IKARUS C42: Rudder bellcrank.

All IKARUS C42 up to and including 9701-6022, January 1997.

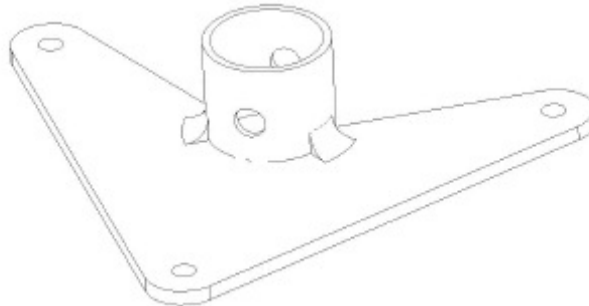
During the inspection of a C42, a crack was discovered in one of the welded joints on the topside of the rudder bellcrank.

Check the welded joints on the rudder bellcrank for cracks according to the instructions given below.

Check the welded joints on the topside and underside for cracks

If cracks are detected, the affected part must be replaced before the next flight.
